AIR - REWORK OF STAGE 10 AIR SOLENOID VALVE MOUNT BRACKET - CATEGORY 3 -  
MOD.ENG-75-0003

(2) Engine: V2500-A1 Engine, Serial No.V0014

V2500-ENG-75-0003

Location of the bracket  
Fig.1

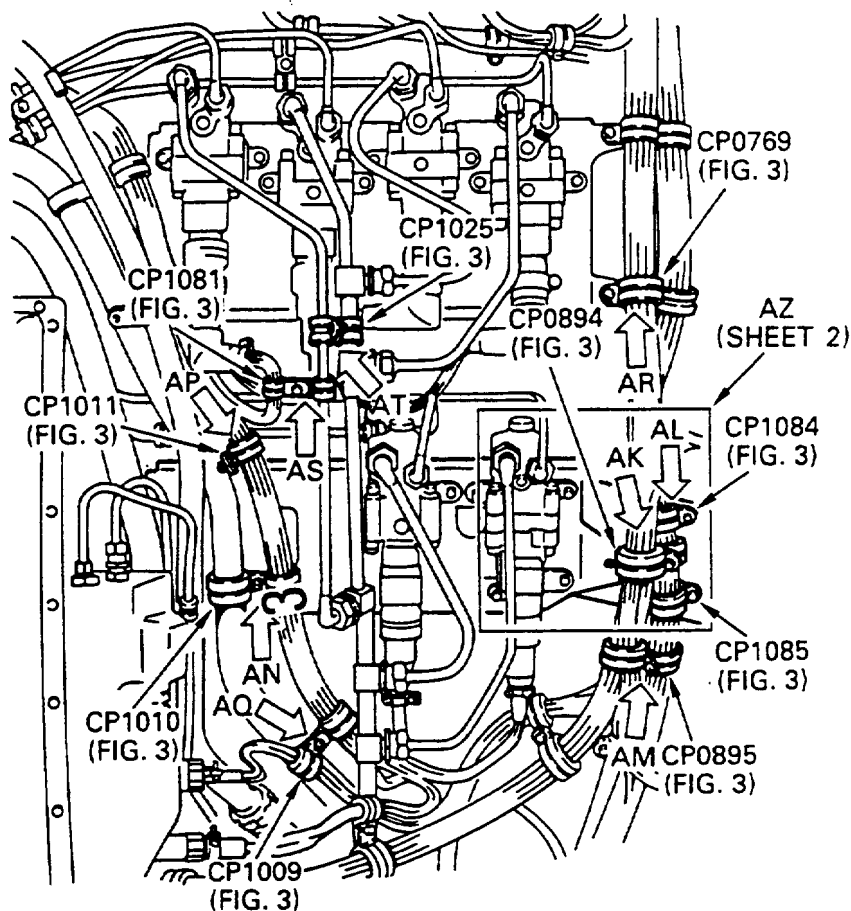
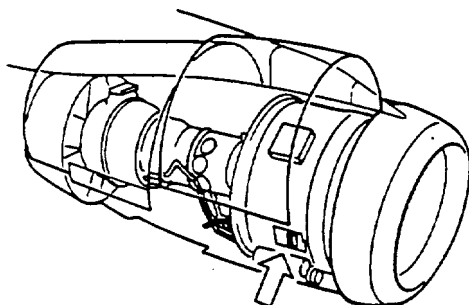
- (1) The clearance between the solenoid valve mount bracket and the EED fan harness is to be increased as follows:
  - (a) The angled protrusion of the existing bracket is cut off, (Refer to Figure 1 and 6). This may give the sufficient clearance between the solenoid bracket and the EEC fan harness.
- (2) The existing PN 5A9158 bracket can be reworked to a new configuration. (Refer to Figure 6).
- (3) New solenoid valve mount bracket will be available for replacement purposes.

View on right-side of the fan case - Before and after alteration  
Fig.2 (Sheet 2 of 2)

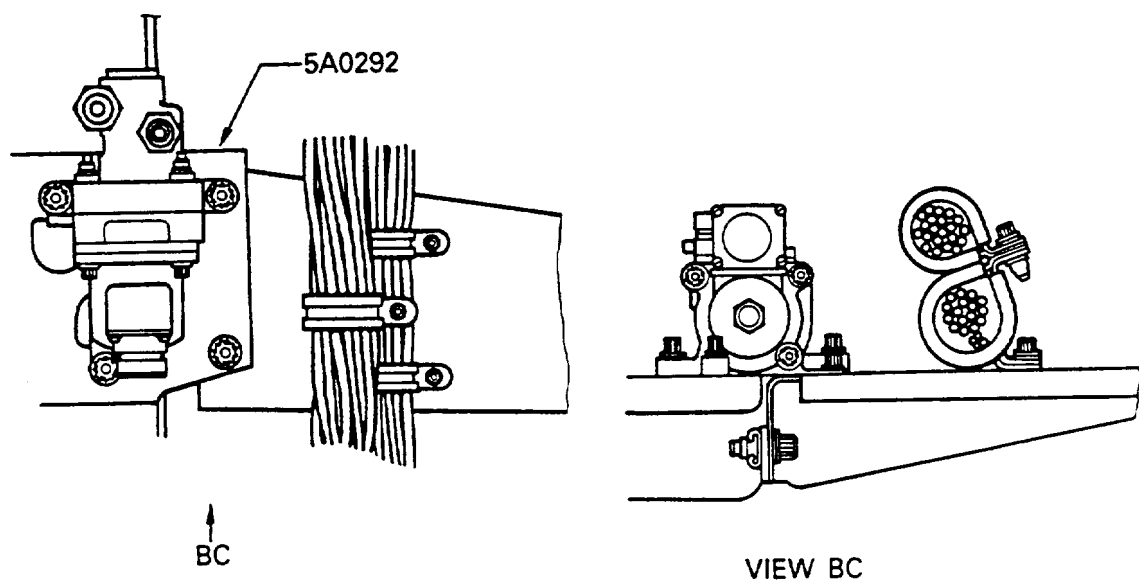
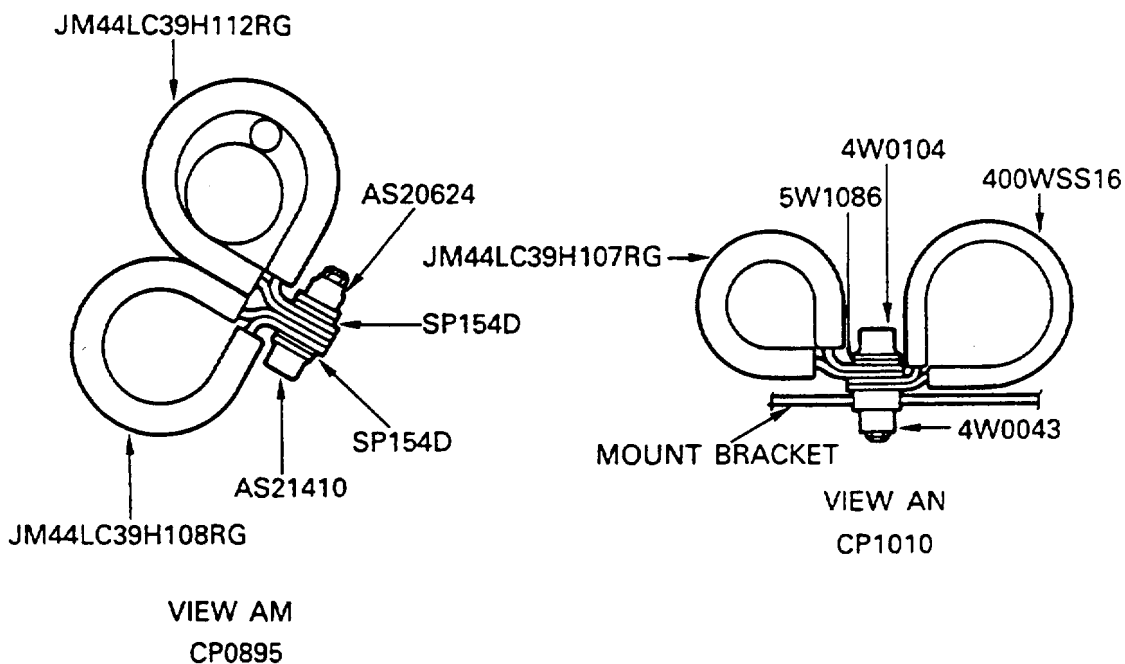
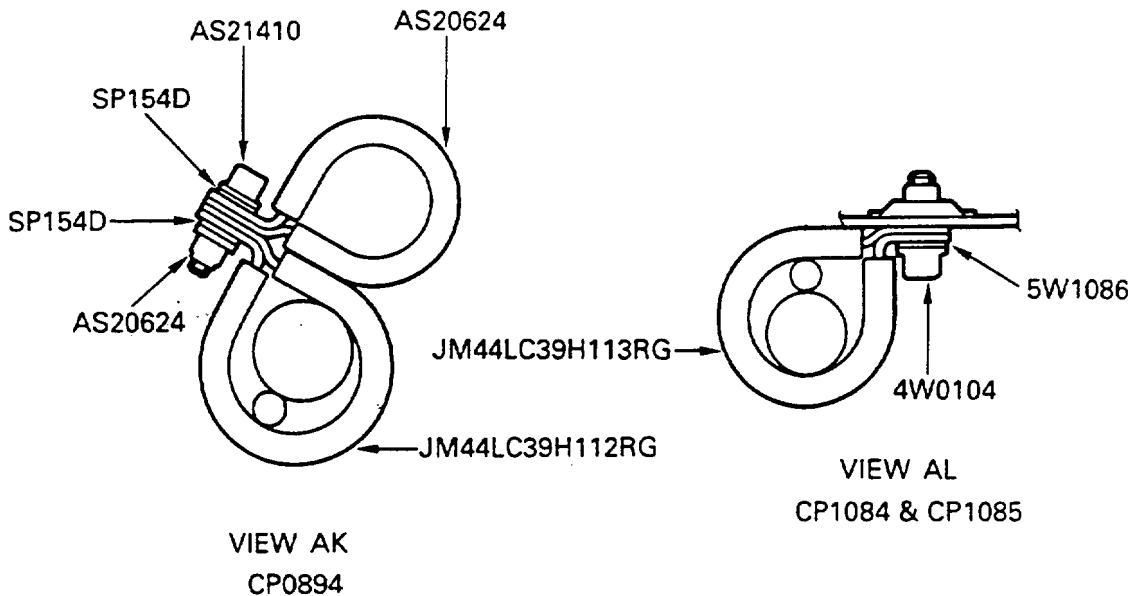
On only Engine serial No.V0014 the re-designed solenoid valve mount bracket was not installed, and the re-designed starter air duct support was installed, then the possibility of the chafing still remains. (Refer to Figure 2, Sheet 2).

Details of the clipping points - Before and after alteration  
Fig.3 (Sheet 1 of 2)

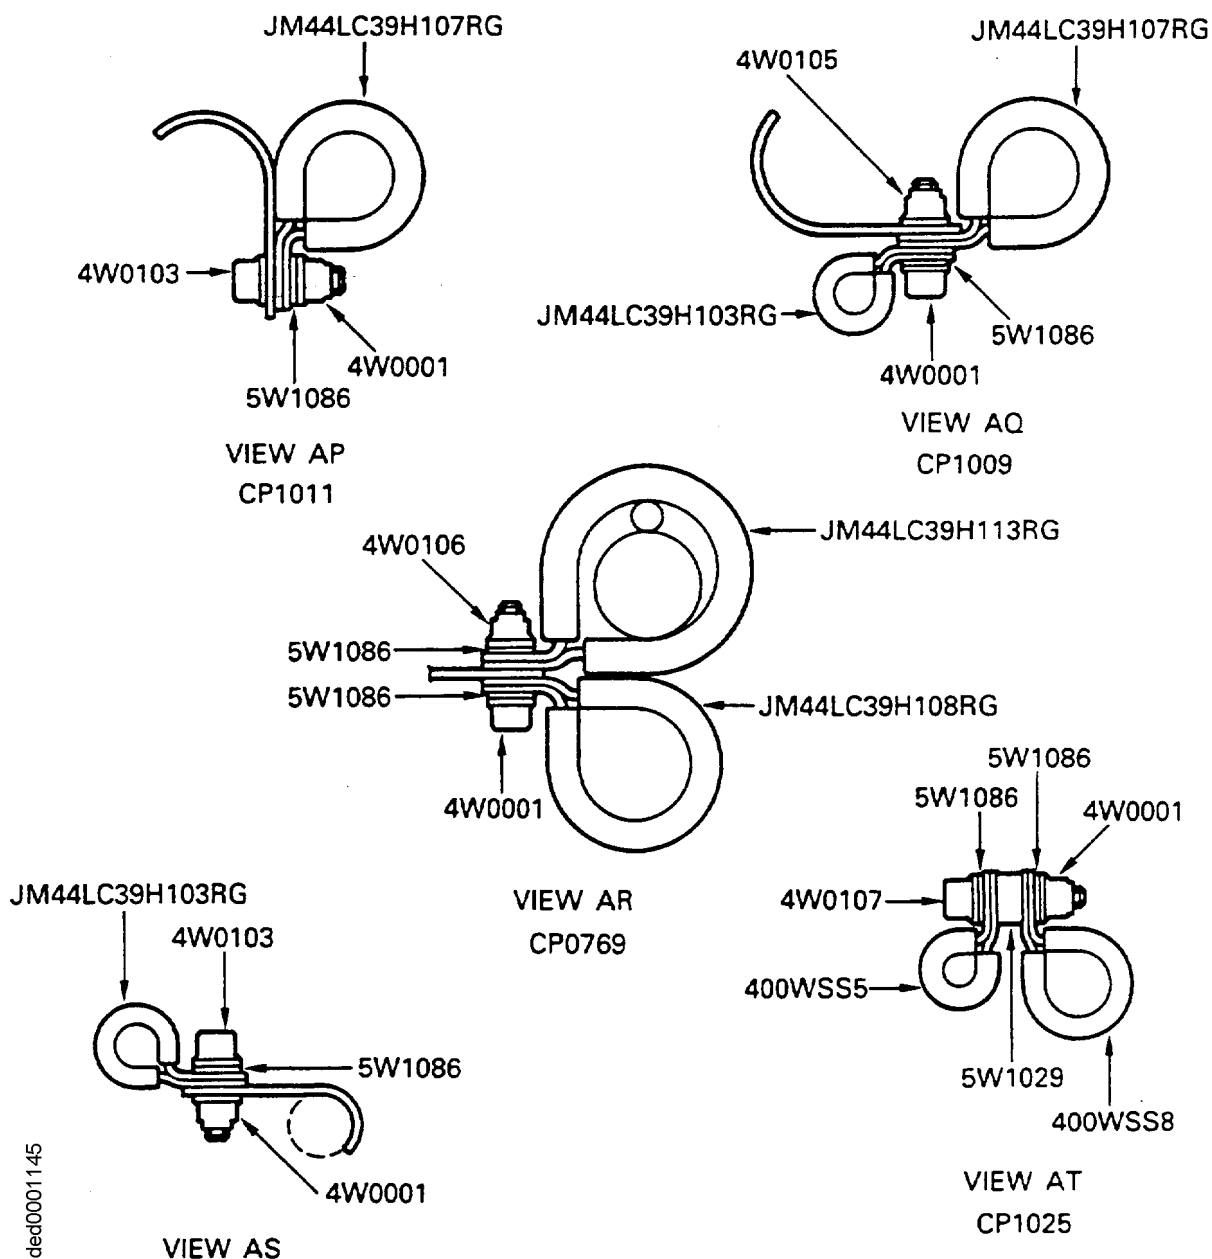
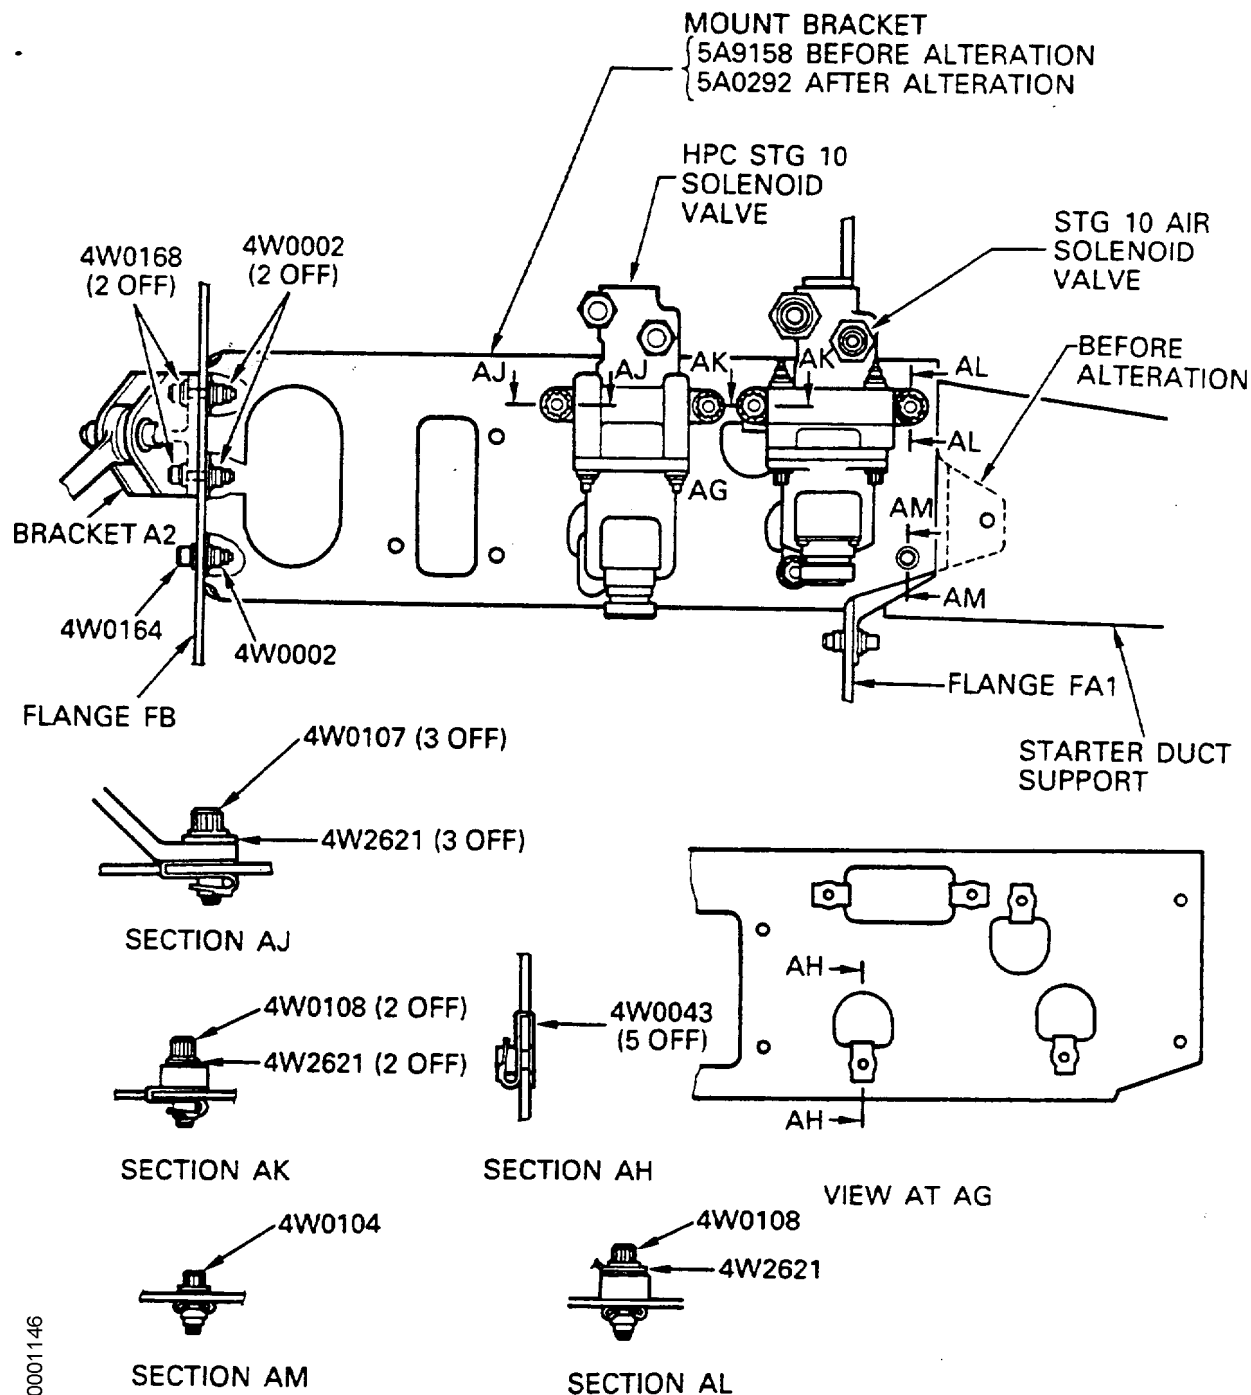
NOTE: If you need to remove the clipping points before the removal of the solenoid valves and the mount bracket, make sure of the locations and the configurations of the clipping points on Figure 2 (sheet 1) and 3, and remove them.

Procedure	Supplementary Information
NOTE: The following steps do not give the instructions for the installation of the clipping points except CP1010.	
NOTE: If the clipping points have been removed in step A, make sure of the locations and the configurations of the clipping points on Figure 2 (sheet 1) and 3, and install them.	
(1) Install the solenoid valve mount bracket.	Refer to Figure 3 (Sheet 1) and 4.
(a) Install the new PN 5A0292 mount bracket to the flange FB and the starter air duct support.

Securing details of the solenoid valve mount bracket - Before and after alteration  
 Fig.4

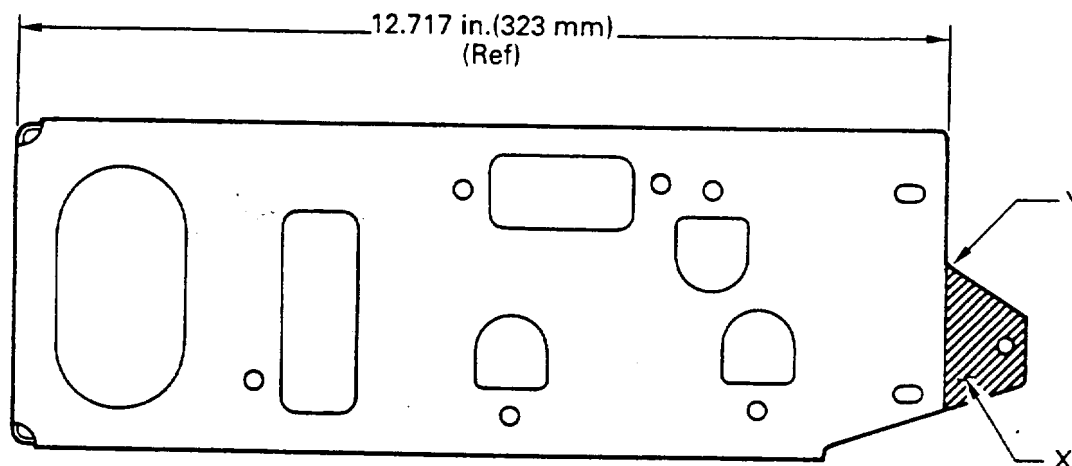
- (g) Remove the HPC stage 10 solenoid valve.
  - (h) Put all the applicable covers/caps/plugs on all of the opening.
- (4) Remove the solenoid valve mount bracket. Refer to Figure 3 (Sheet 1) and 4.

- (b) Attach the PN 4W0164 bolt and the PN 4W0002 nut to the mount bracket and the flange FB.
- (c) Attach the two PN 4W0168 bolts and PN 4W0002 nuts to the mount bracket, the flange FB and the bracket A2.

- (d) Attach the PN 4W0108 bolt to the mount bracket and the starter duct support.
- (e) Torque the four bolts installed in steps (b), (c) and (d) to 100 lbfin (1,13 mdaN). Refer to the Aircraft Maintenance Manual, 70-23-11, Torque Tightening Technique.

- (f) Attach the PN 4W0104 bolt the PN 5W1086 washer and the 4W0043 clipnut to the clipping point CP1010 and the mount bracket. Torque the bolt to 100 lbfin (1,13 mdaN). Refer to Aircraft Maintenance Manual, 70-23-11, Torque Tightening Technique.

Rework of the mount bracket  
Fig.6

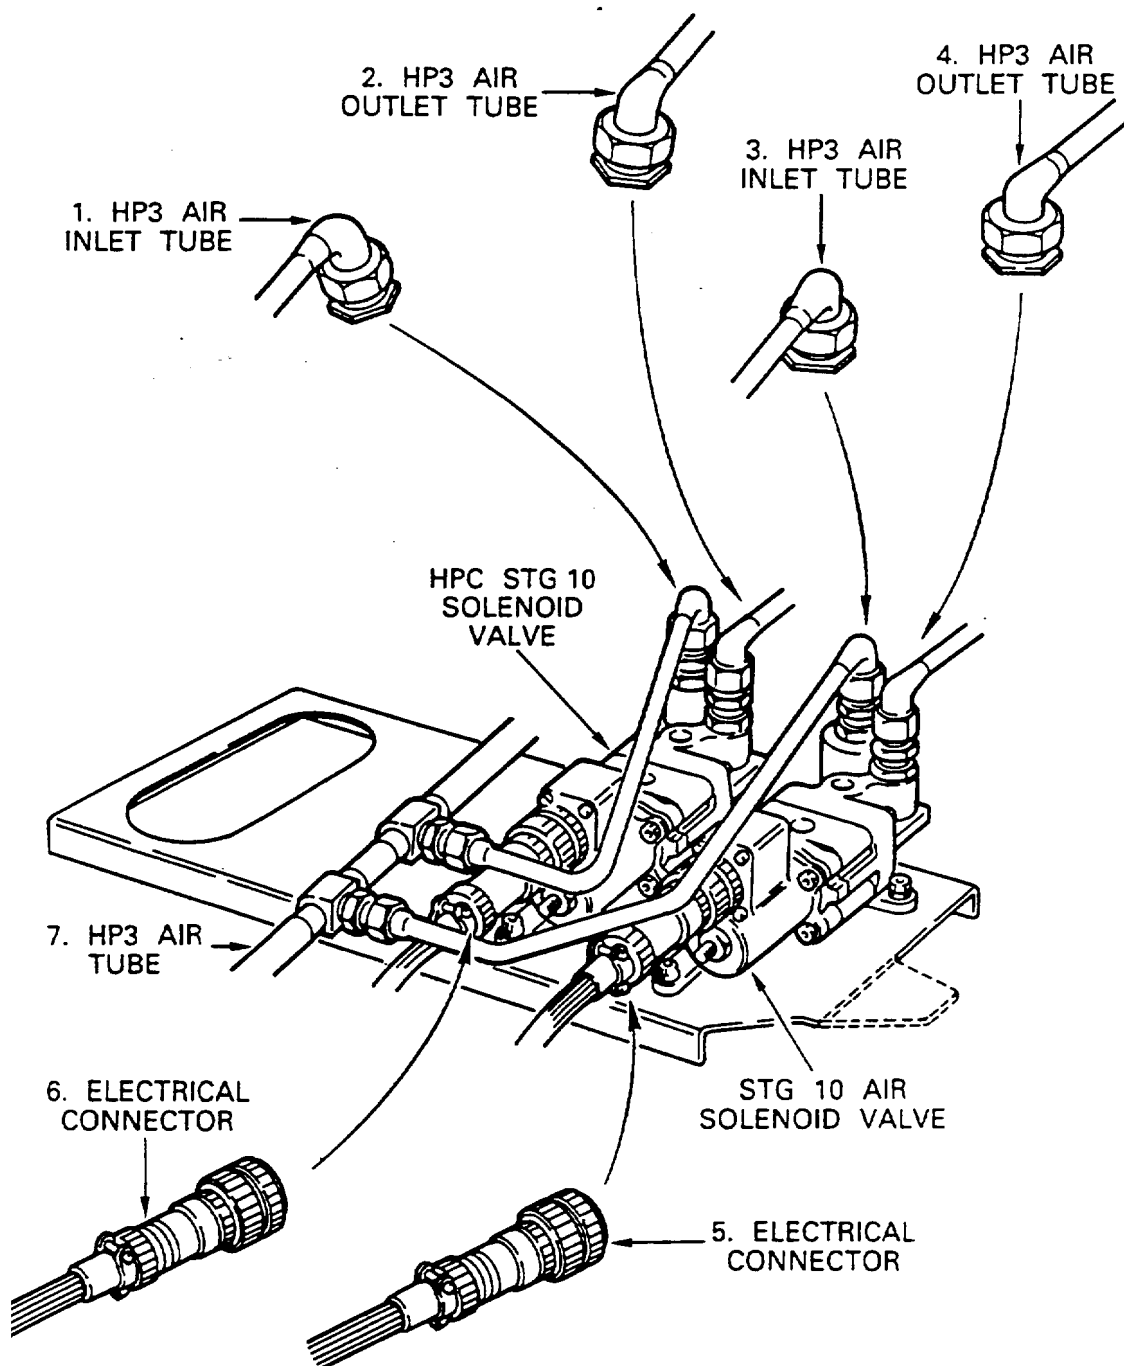
Procedure	Supplementary Information	
(1) Cut off the angled protrusion from the bracket.	Refer to Figure 6.	
(2) Renumber by the vibro-peen adjacent to the old part number on the bracket.	Old Part Number 5A9158	New Part number 5A0292

- 1 Cut off the shaded portion X of the Bracket with a handsaw or a wire electro discharge machine.
- 2 Blend mismatch at the intersection Y with a file or an abrasive stone.
- 3 Break the sharp edges in the limits between 0.002 in.(0,05 mm) and 0.019 in.(0,50 mm), with a file or an abrasive stone.

USE VIBRO-PEEN TO IDENTIFY NEW  
PN 5A0292 ADJACENT TO EXISTING  
PN 5A9158 IDENTIFIED HERE.  
MARK TWO LINES (==) ON EXISTING  
PN WITH VIBRO-PEEN TO ERASE IT.
